RIDGEFIELD HIGH AND MIDDLE SCHOOL INTERCONNECTION  
Ridgefield, Connecticut

**ADDENDUM NO. 1**

February 6, 2026

### CONTRACT DRAWING - REVISION NO. 1

SITE PLAN		DRAWN YEAR		CHECKED ZAK YER		REVISED ADDENDUM NO.1 2/3/2026
DESIGNED ZAK

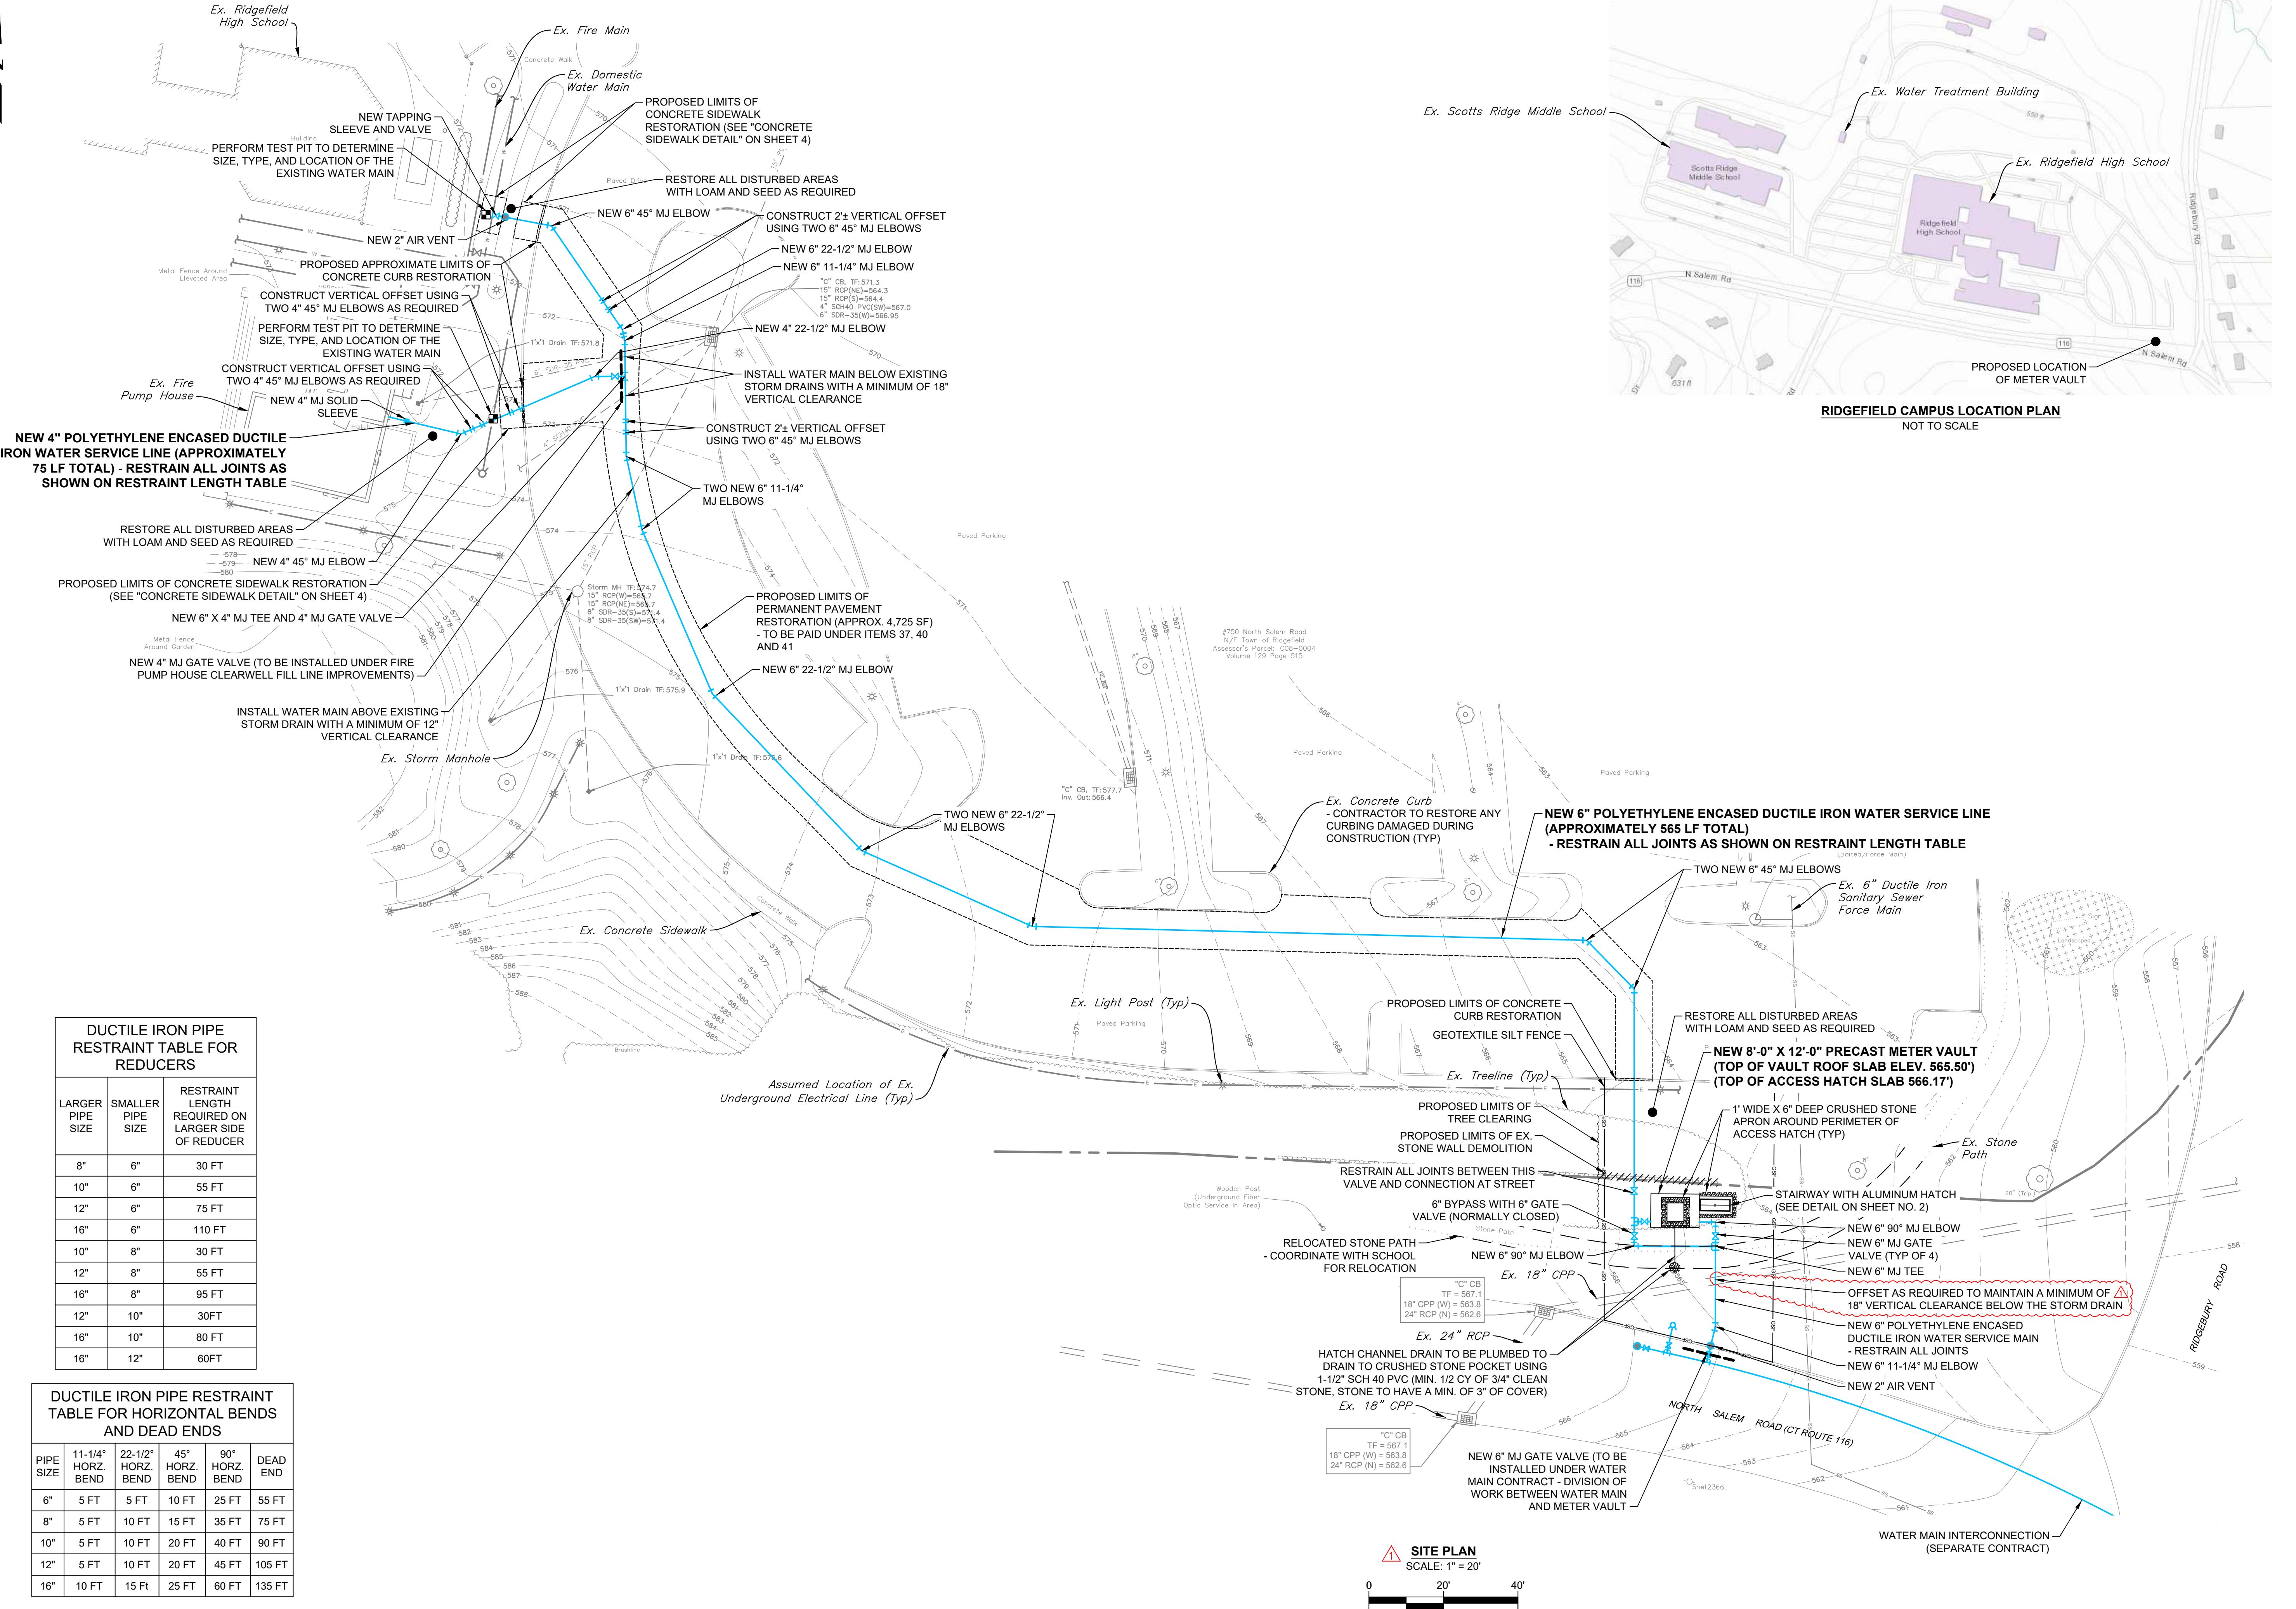
- 4. Attached are the revised Contract Drawings titled, “Ridgefield High and Middle School Interconnection” and dated 2-3-2026. The revisions generally include the following:
- On Sheet 1, noted that the water service to the school be located with an 18" minimum vertical clearance under the existing 18" CPP storm drain per CTDOT Comments.

ADDENDUM 1  
REVISED: FEBRUARY 2, 2026

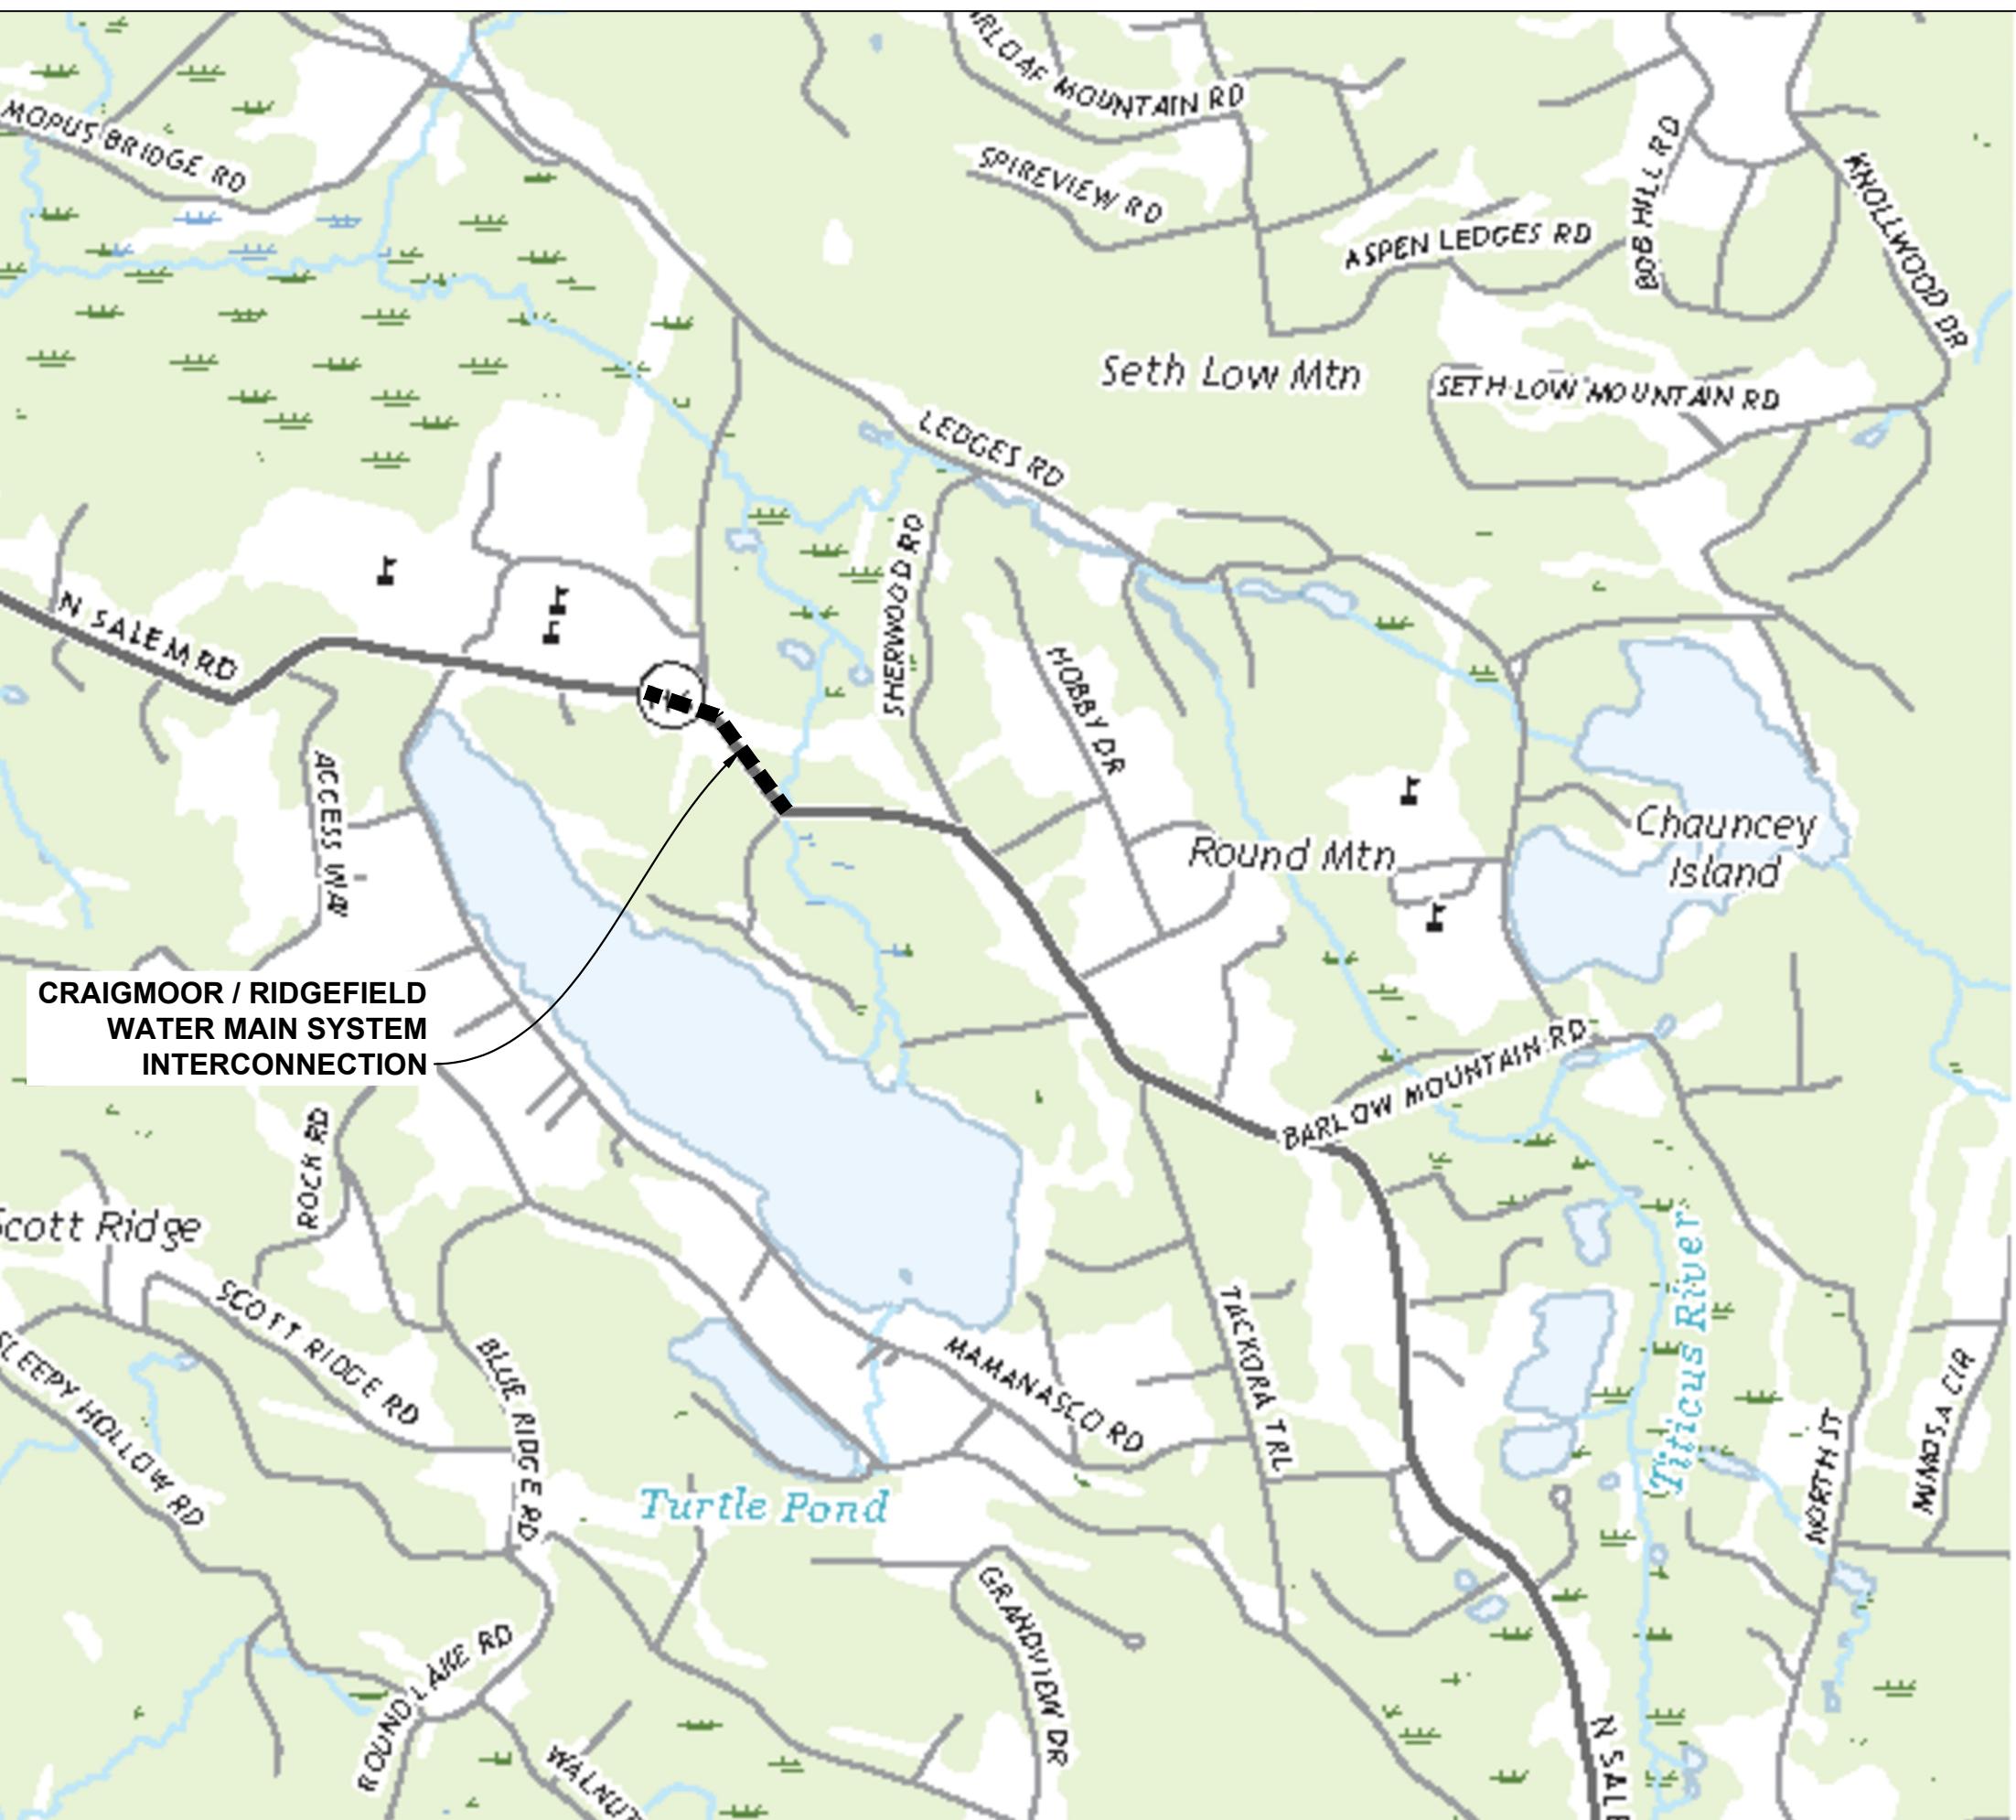
5. Attached are the revised Contract Drawings titled, "Ridgefield High School Water Main Extension" and dated 2-2-2026. The revisions generally include the following:

- On Sheet 1, the alignment of the water main was revised to be located with an 18" minimum vertical clearance under the storm drain at the approximate location STA. 3+20 per CTDOT Comments.
- On Sheet 1, the proposed hydrant was relocated to STA. 4+06 per CTDOT Comments.
- On Sheet 1, noted that the water service to the school be located with an 18" minimum vertical clearance under the existing 18" CPP storm drain per CTDOT Comments.
